# Section 4.0

Design Evolution

The LB Camden Design Review Panel (DRP) reviewed 18a Frognaal Gardens on Friday 27th March 2020. The notes from this meeting are included as an appendix to this document.

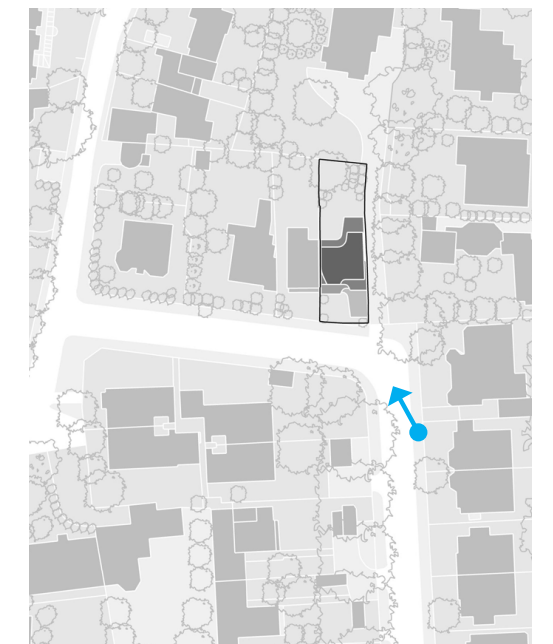
Design Review Panel's views			Design Response
5	<b>Massing</b>	Mass of the building to be reduced in small ways to prevent it from seeming over-dominant. Design to be carefully examined to identify areas where its mass can be subtly reduced, particularly:	Height reduced by 350mm, and setbacks introduced on top floor: new curved setback from the west party wall, new setback to the east and increased setback to the south

A. Around the roofline	Height reduced by 350mm, and setbacks introduced on top floor: new curved setback from the west party wall, new setback to the east and increased setback to the south

B. Chimneys	Chimneys reduced in height, width & depth
		C. Where front elevation projects beyond building line of No. 18b Frogna Gardens	150mm reduction in height to this element
6	<b>Massing</b>	New building could eventually, or theoretically, form one half of a semi-detached pair of houses, and its design and massing could reflect this	Height reduced by 350mm, and setbacks introduced on top floor: new curved setback from the west party wall, new setback to the east and increased setback to the south. Proposed 'dormer' arrangement of 2nd floor in particular. Bay window articulates the entrance and introduces the vertical rhythmic sequence of bays.
7	<b>Massing</b>	Adjustment to the height of the right-hand side recessed element at top floor would lessen the dominance of this elevation. The left-hand side of the top storey also feels dominant in relation to the adjoining house, and could also be reduced in height	Height reduced by 350mm & setbacks introduced to the east and increased setback to the south, gable with curved transition aligning the parapet with 18b

1. Height to top of chimney reduced by 750mm
2. Height to top of roof reduced by 350mm
3. Curved 1220mm setback to east gable wall
4. 230mm setback to top floor front wall
5. 450mm top floor setback from west gable wall
6. 1st & 2nd floor levels reduced 150mm
7. Window height reduced by 650mm
8. Front extension reduced by 1575mm and planting zone increased to 3320mm.
9. More opaque planting to boundary with 18b

### 4.4 Further Set back of Front Extension

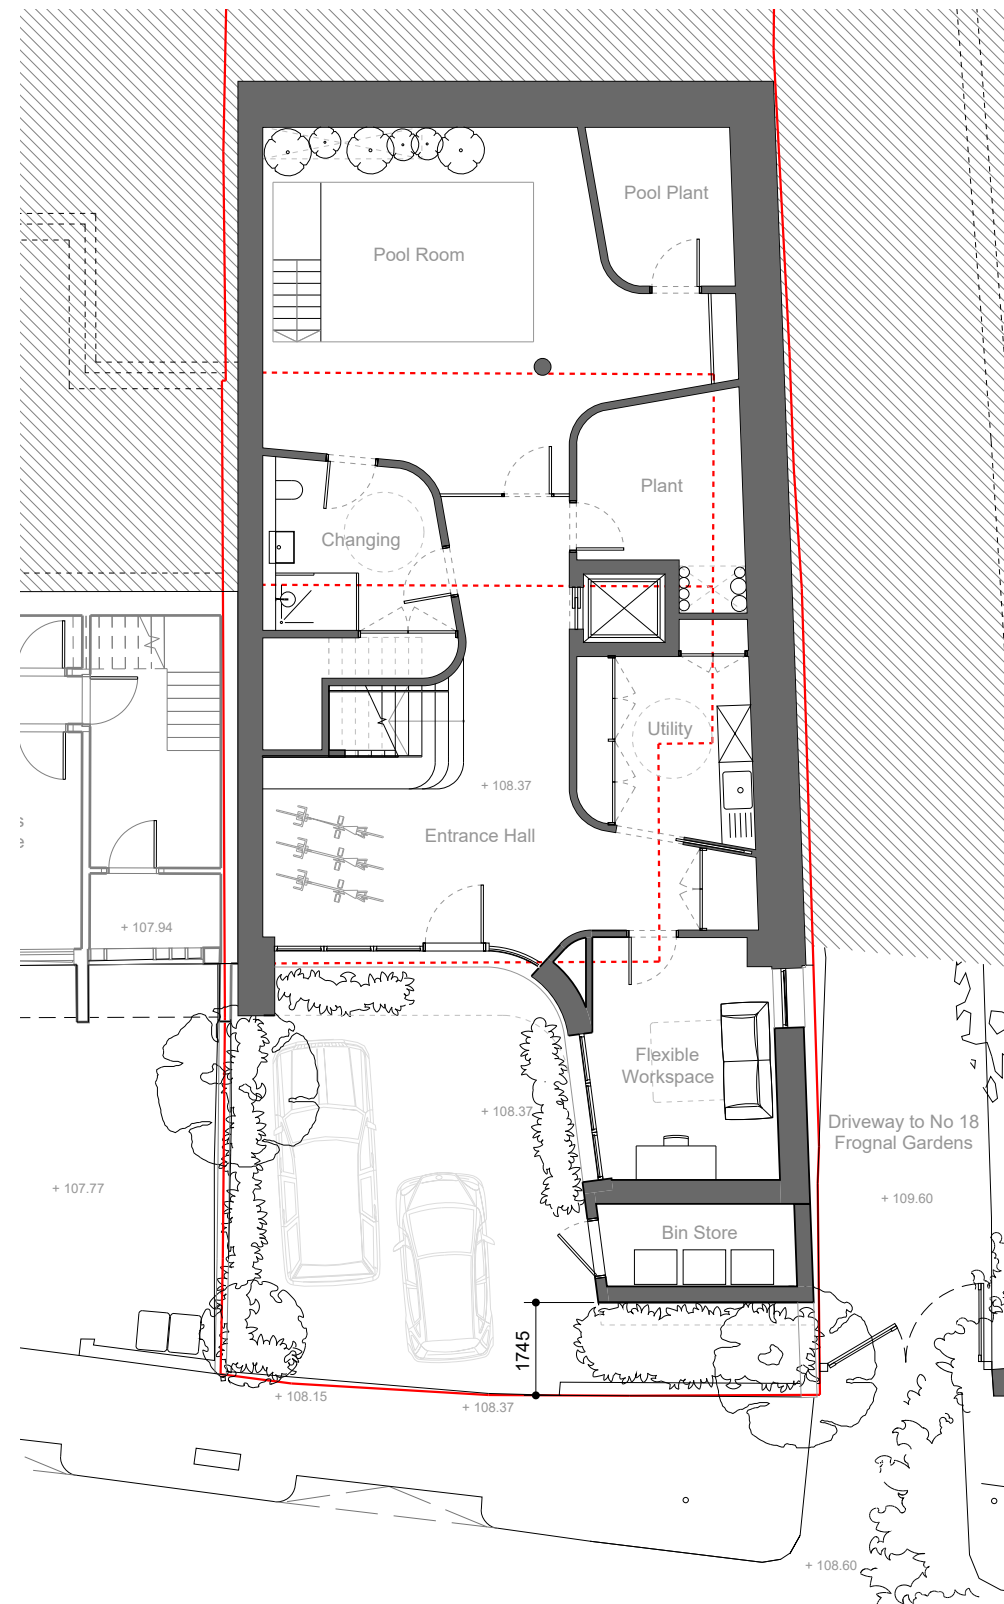
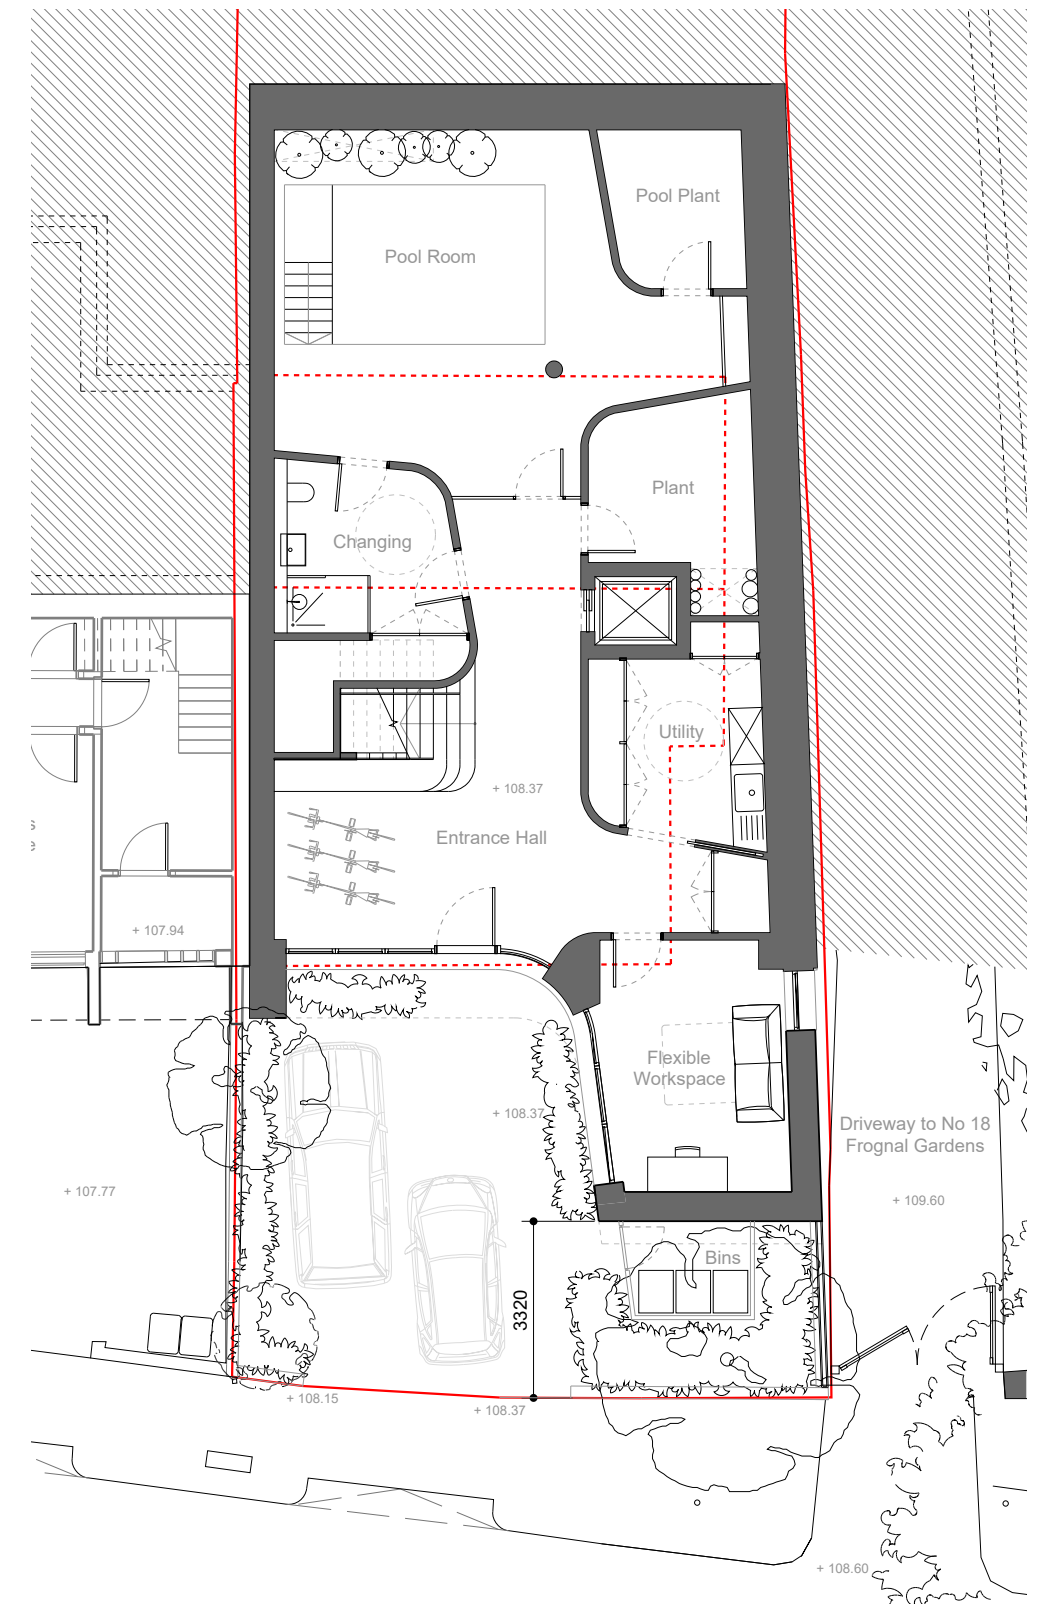
In response to LBC's request to set the projection at least 3m back from the back of the pavement, ABA have introduced a 3.32m setback to the lower ground floor projection, to provide a more generous area of planting. Together with landscape architect Jo Thompson, ABA have further developed the planting scheme in this area to ensure that it forms a meaningful landscaped frontage as a contribution to the verdant street-scene. In particular, we have provided additional detail about the proposed tree and its planned growth and management. See the proposed landscaping section of this report.

In order to allow the mass of the house to be reduced at the lower ground floor projection, we have removed the bin store from the house, and integrated it into the landscape.

We propose to conceal the bin store area within a planted bed that follows the level of the adjacent topography. The upper part of the bins will be hidden behind a mirror-polished stainless steel screen. This in turn will be concealed by low and mid height planting and a significant new Acer, which will be reflected in the screen.
